AKOURI CONSULTING ENGINEERS

RE Summary of repairs and recommendations obtained from the Milestone Phase 1 and 2 for
the building located at:

Las Vistas in Inverrary Condominium Association Inc.
3772 Inverrary Boulevard Bldg M, Lauderdale, FL 33319

Unit 202

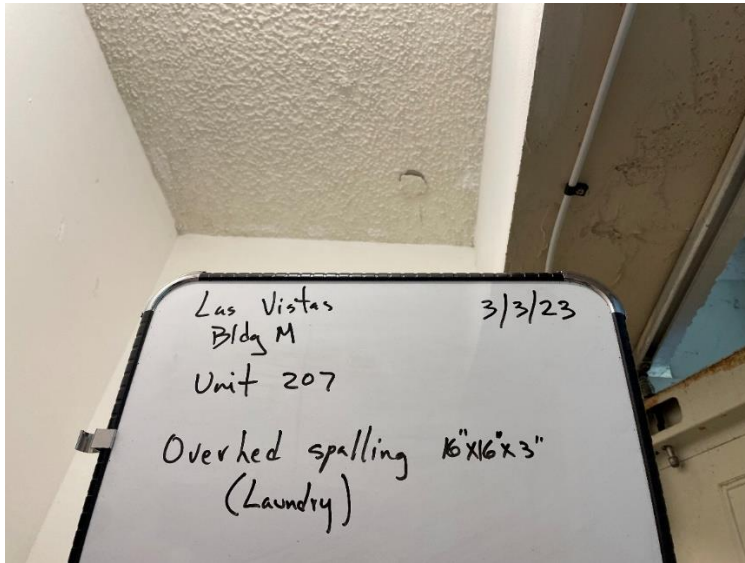
The listed deficiencies below must be corrected in accordance with a concrete restoration bid package prepared by a structural engineer and approved by the Local Building Department.
